ADDENDUM NUMBER 1

- 1.01 DATE: April 7, 2015
- 1.02 PROJECT: Interior Renovations to the Mimosa - G Residence
Ramapo College of New Jersey
- 1.03 SNS PROJECT NUMBER: 4698G

INTERIOR RENOVATIONS
AT THE
MIMOSA - G RESIDENCE

Dwg. Title
FIRST & SECOND FLOOR HVAC PLANS

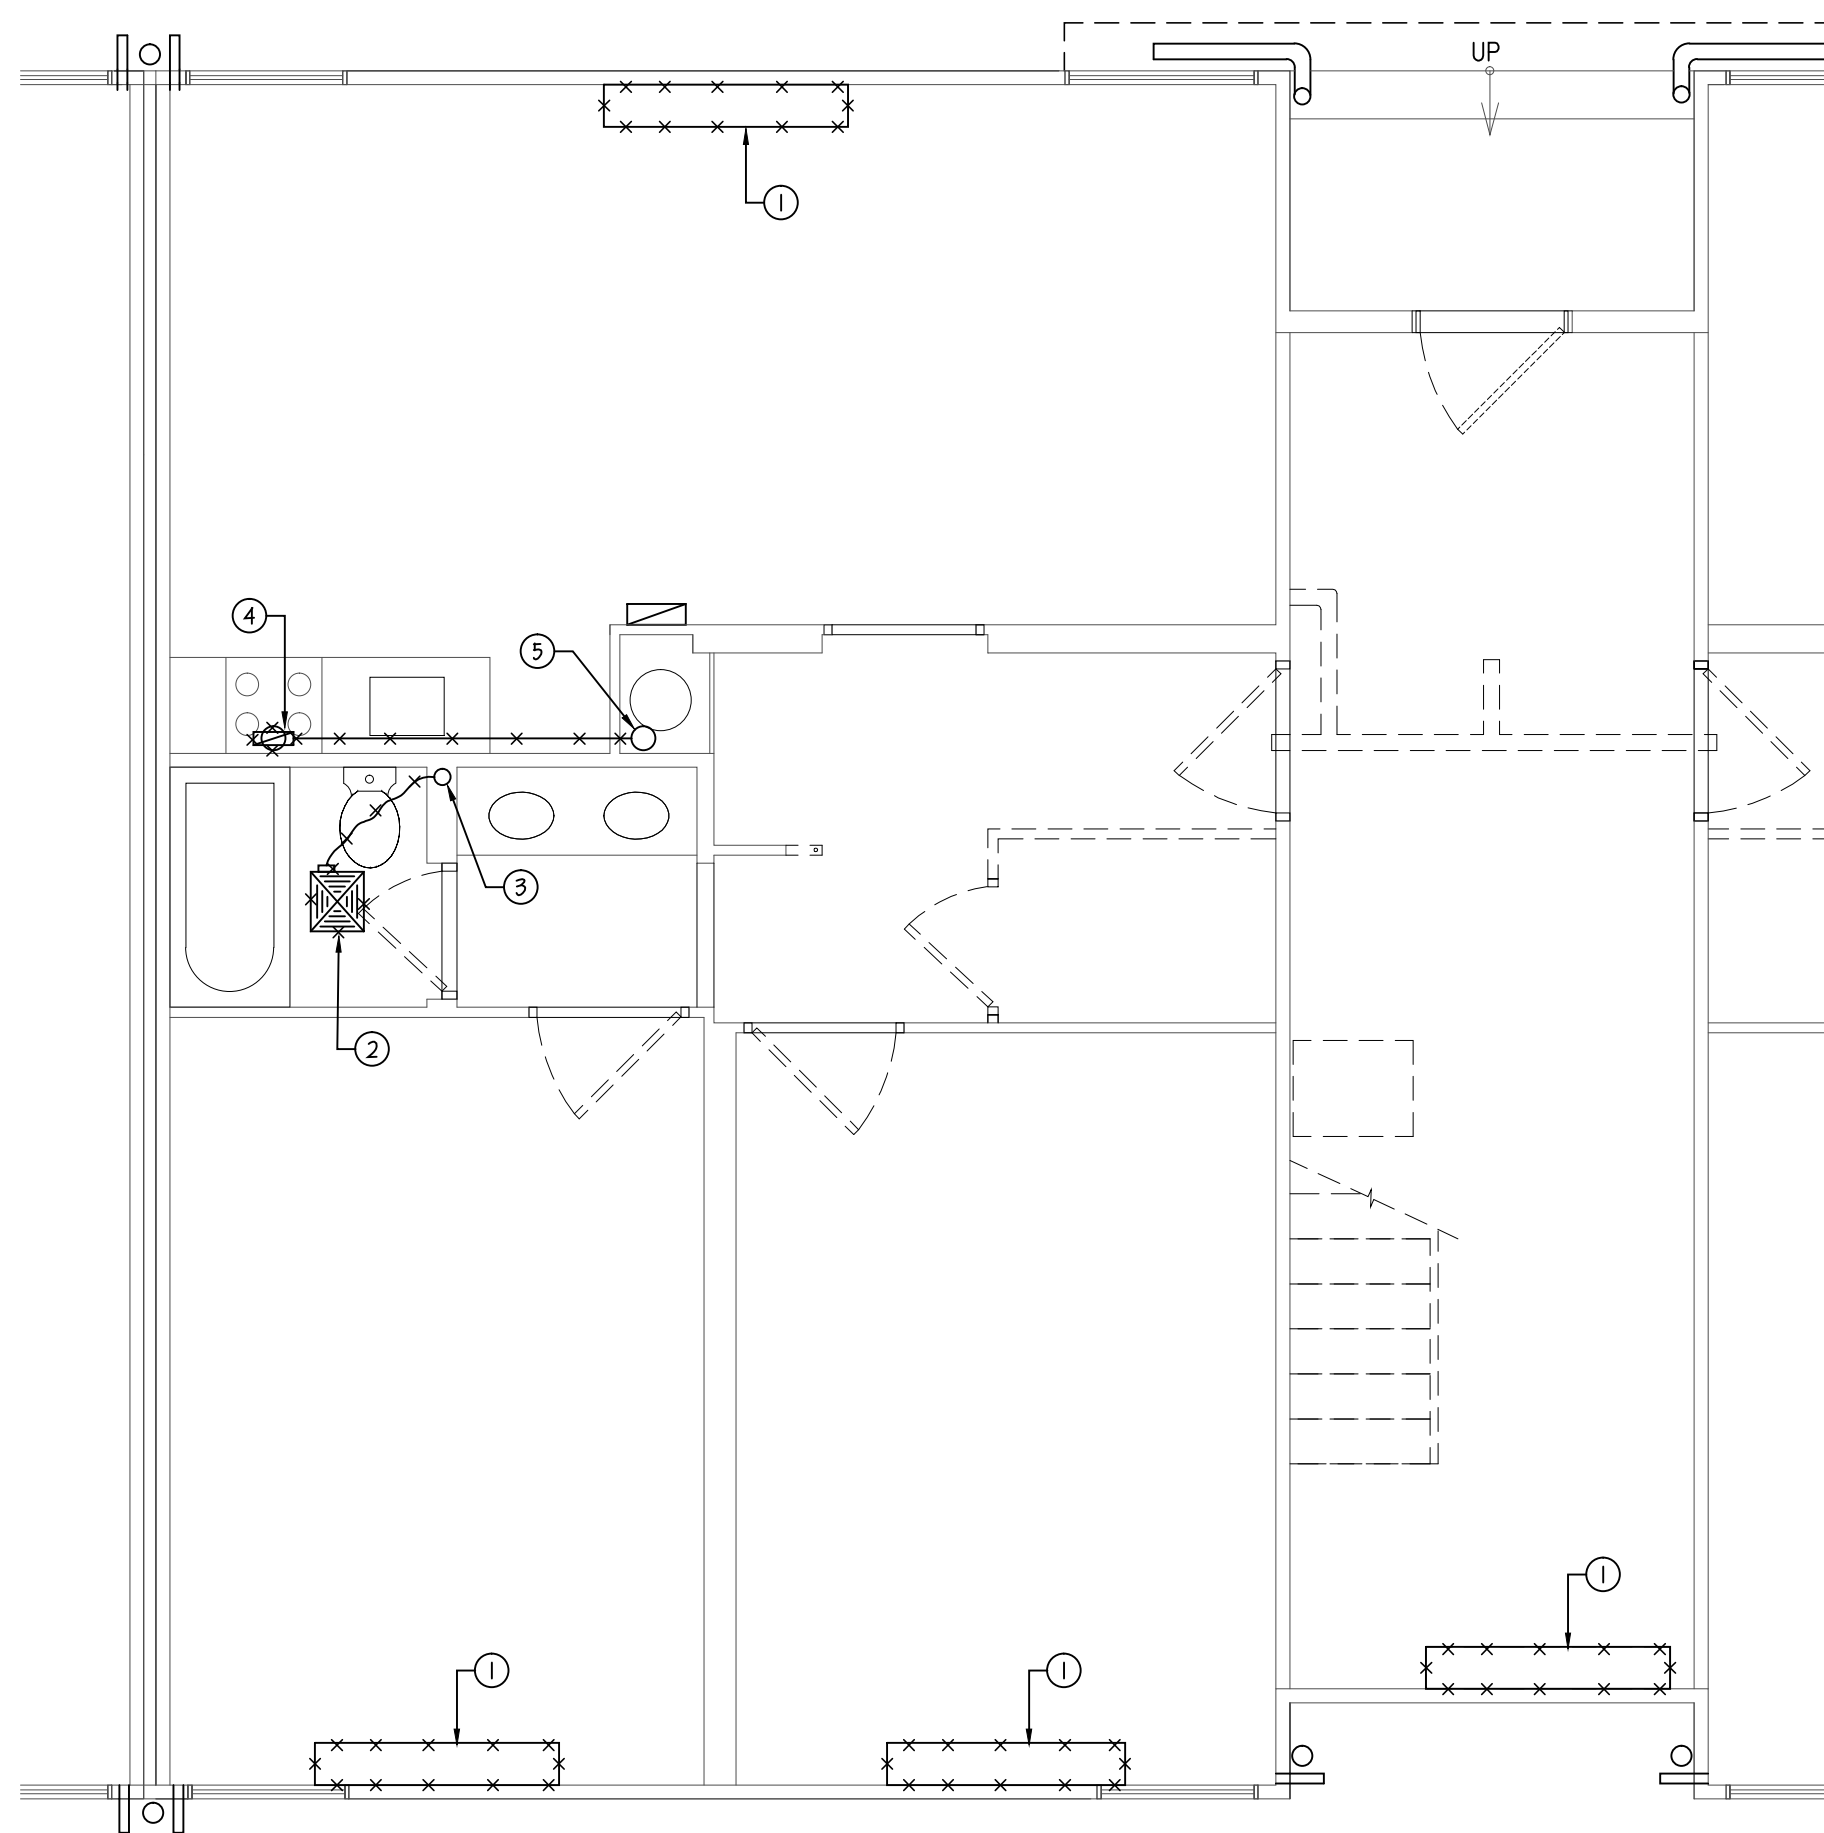
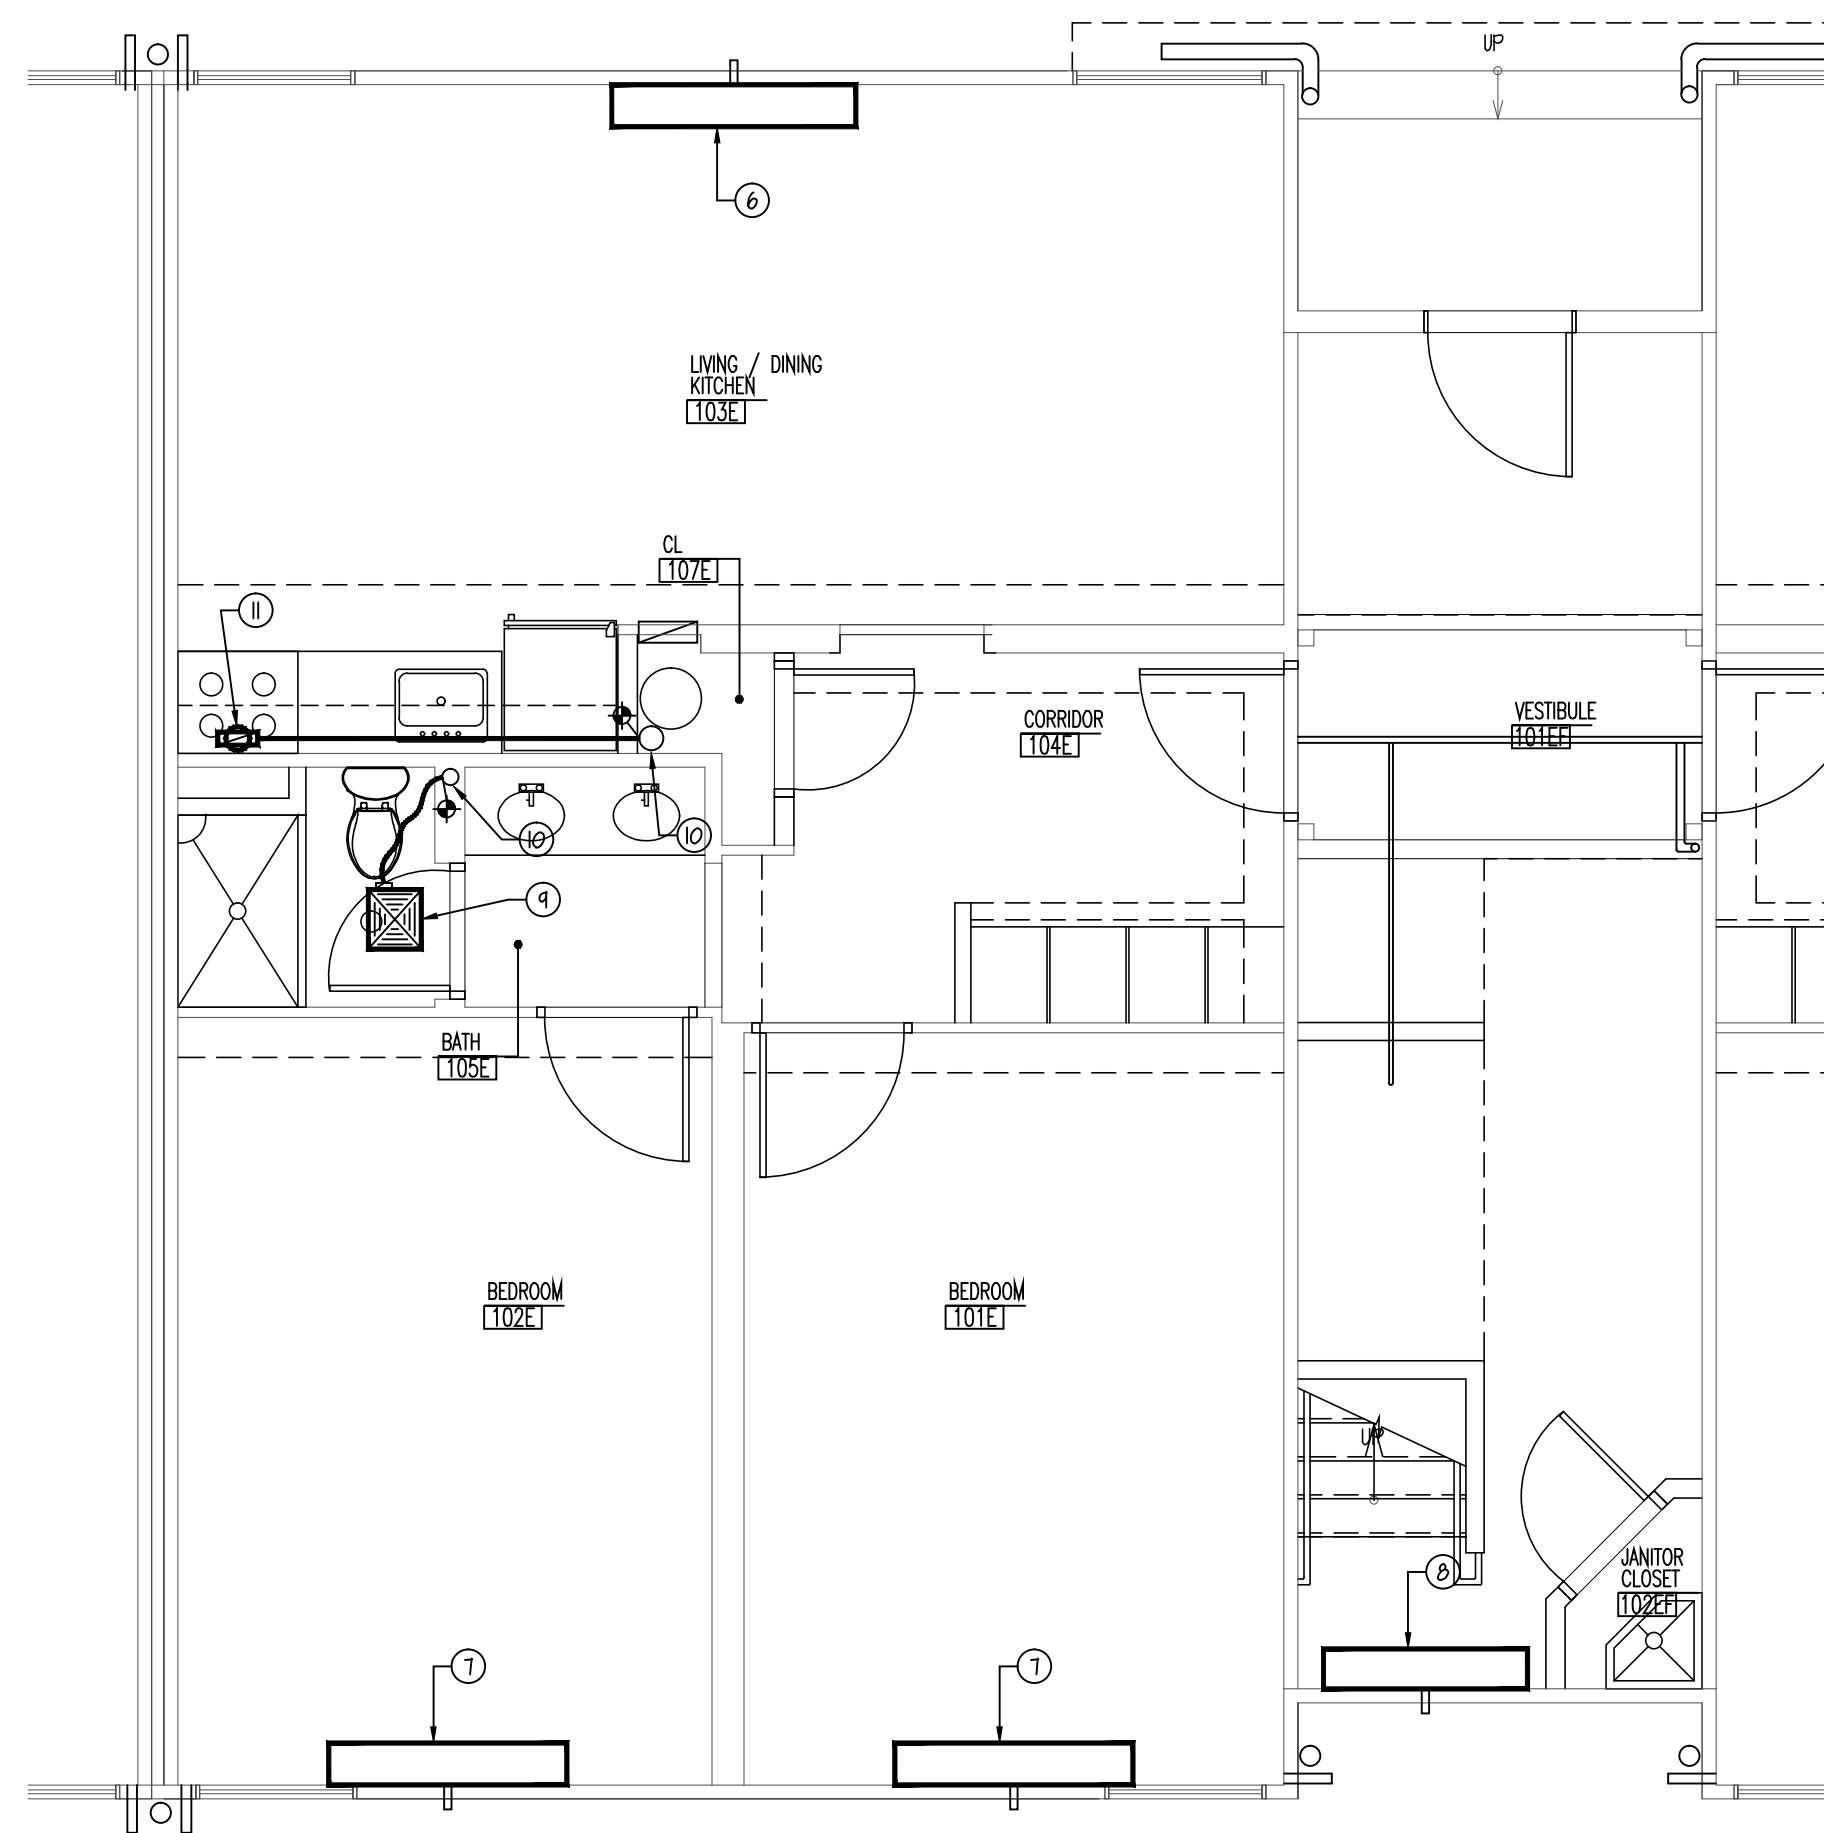
- 5.1. Added exhaust fan EF-1 to IT Closet, key notes and associated fan schedule.
6. DRAWING M200, ENLARGED FIRST & SECOND FLOOR HVAC PLANS:
 - 6.1. Added note indicating that all demolition work is by others under separate contract and filed under separate DCA permit application.
